Detailed Site Plan Alternative Compliance Forestville Center

DSP-16039
AC-21014

SUBJECT: Detailed Site Plan DSP-16039
Alternative Compliance AC-21014
Type 2 Tree Conservation Plan TCP2-004-2025
Variance to Section 25-122(b)(1)(G)
Forestville Center

Figure 1: Detailed Site Plan

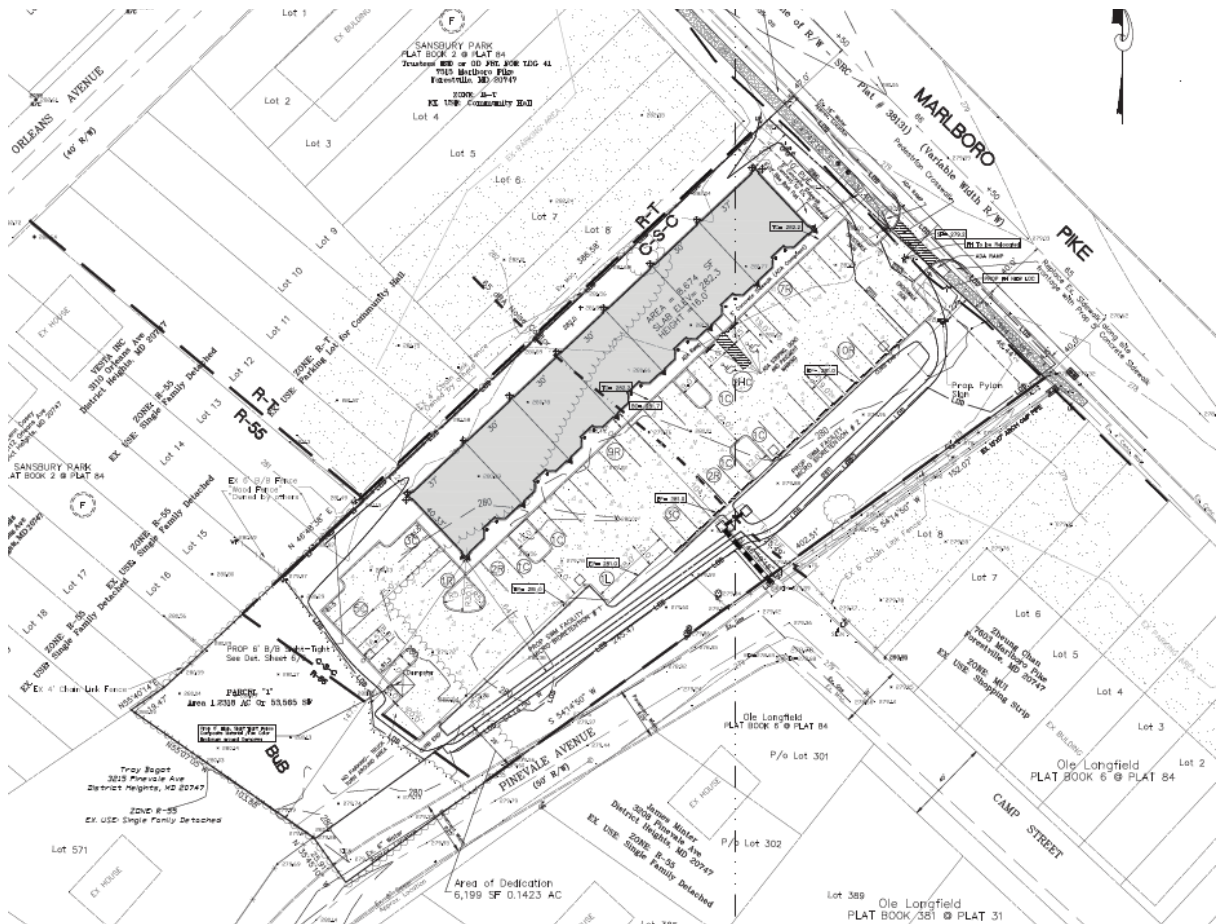
6. **Design Features:** The proposed development of an 8,674-square-foot commercial shopping center will be located on the C-S-C-zoned portion of the property, set back approximately 20.6 feet from the Marlboro Pike right-of-way. The proposed commercial shopping center is a one-story building oriented to the southeast, facing the proposed parking area. The parking area is located along the front and side of the building.
